FAO:
An Bord Pleanála
64 Marlborough Street
Dublin 1

Re: Strategic Housing Development application (Ref. ABP-TA29S.313278) at White Heather Industrial Estate, South Circular Road, Dublin 8.

Picture 1: Grand Canal View omitted from picture and highly overbearing design on unit 13B.

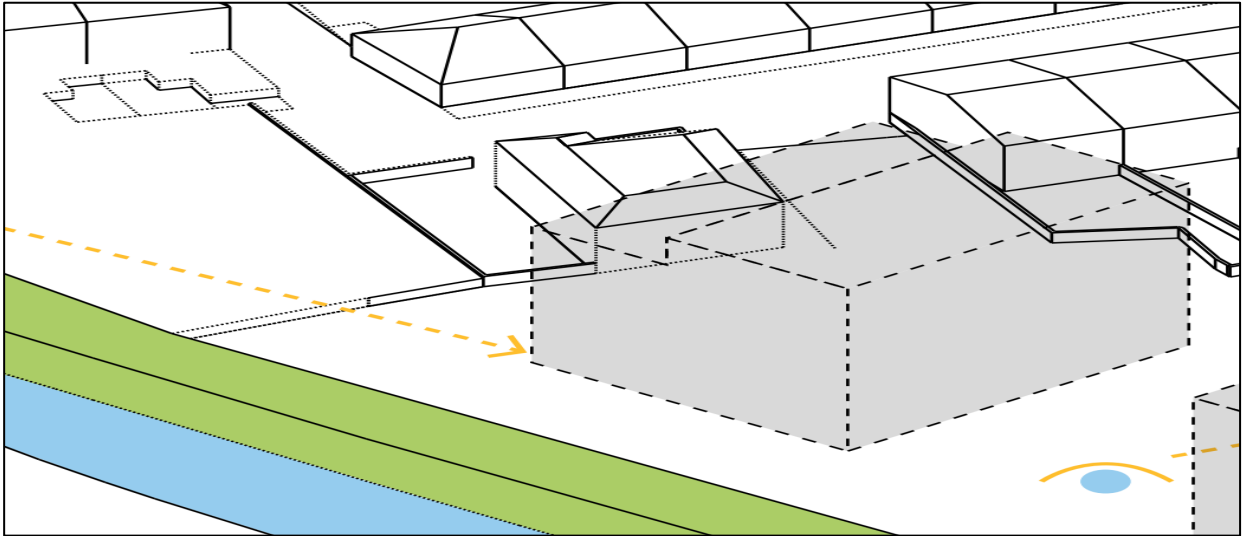
- a. Whilst it might be deemed as only 5 stories in height, this building is by far the most grossly overbearing within the development.
- b. For numerous reasons, I can't accept or understand how Block 01 could be deemed by ABP as appropriate in design, height or scale. It shows zero consideration for neighbouring properties.

Conclusion: Height has now become the main drawback for observers on proposed developments, with nearby locals fighting for reduced overall schemes on a regular basis. Therefore, narratives can often fall on deaf ears in such circumstances. However, I do not believe the three visual extracts from the planning application can be easily overlooked by ABP when considering the reasonableness of this application. I am pro regeneration and development, however, I cannot ignore or accept the impact Block 01 will genuinely have on the surrounding residents. Whilst only 5 stories in height, it has a more detrimental impact than any other given it's encroaching distance from existing buildings.

Picture 2: Omission of 13B which would demonstrate over bearing nature of Block 01

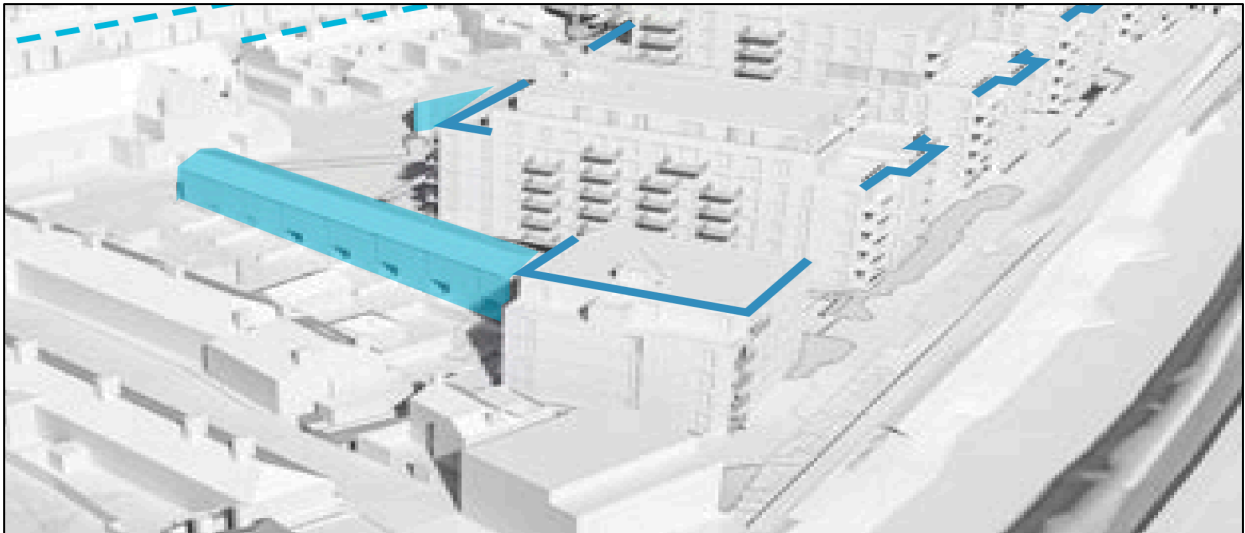
- a. Block 01 is 5 metres from 13B St. James's Terrace

- b. The living room window of the North-East facing unit of the block is 8 metres from direct viewing of the residents bedroom. That is under 35% of the recommended distance.
